1 Products affected

Product Change Notification					OGN Cover isolation material change			
owner	creation date	release date	released by	change order no	rev	page	D10 007 057	
dislercy	2016-08-11	2017-02-01	nowakfr	2011797	А	1 of 1	D10-007-257

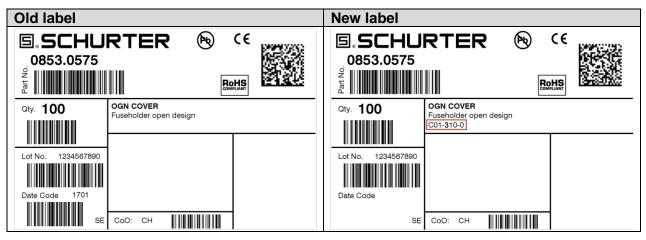
- Change of material
- Modified label

The new material fulfils the glow wire requirements given in IEC60127-6:2014 and are free of halogenated flame retardant and red phosphorus.

Product improvement to fulfil the enhanced glow wire requirements according to the updated standard IEC 60127-6:2014 and the standard IEC 60335-1 for appliances in unattended use.

Form	Yes	Transparent plastic material changed
Fit	No	No change for dimension
Function	No	No change in function
Manufacturing	No	No change for manufacturing site
Label	Yes	Configuration code on label
Packaging	No	No change in packaging
